CORRIGENDUM-3

Ref: TPCODL/P&S/72/2020-21/Corrigendum/03

Sub: Replies to Pre-bid queries (Annexure-1), Modification to BoQ and Addition/Modification to Technical specification & Drawing of Tender number TPCODL/P&S/72/2020-21 Reference Document- Our Tender number TPCODL/P&S/72/2020-21 for Rate Contract for 11kV and 1.1 kV associated works (Construction / Augmentation) all over TPCODL area for releasing new HT < connection & other misc. Distribution electrical works

ANNEXURE-B- Addition / modifications to Tender specification & Drawings

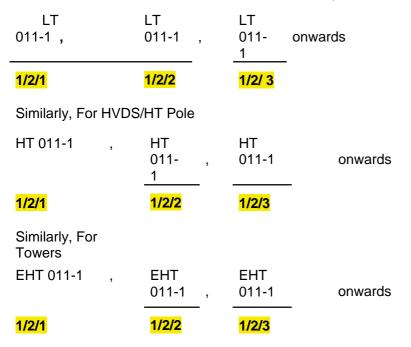
Case 2: In case two T-off from one pole are there then two different T-off will be numbered separately. e.g. For

LT Pole/FP/SP, Ist pole onwards from 1stT-off shall be numbered as (mentioned in bold)

LT 011-1 ,	LT 011-1 ,	LT 011-1	onwards
	<mark>1/1/1</mark>	<mark>1/1/2</mark>	<mark>1/1/ 3</mark>	
Similarly,	For HVDS/HT	Pole		
	HT	HT	HT	
	011-1,	011-1 ,	011-1	onwards -
	1/1/1	1/1/2	1/1/3

Similarly, For Towers

<mark>1/1/1</mark>		<mark>1/1/2</mark>	1/1/3	
	011-1,	011-1,	011-1	onwards
	EHT	EHT	EHT

Ist Pole onwards from 2nd T-off shall be numbered as (mentioned in bold)
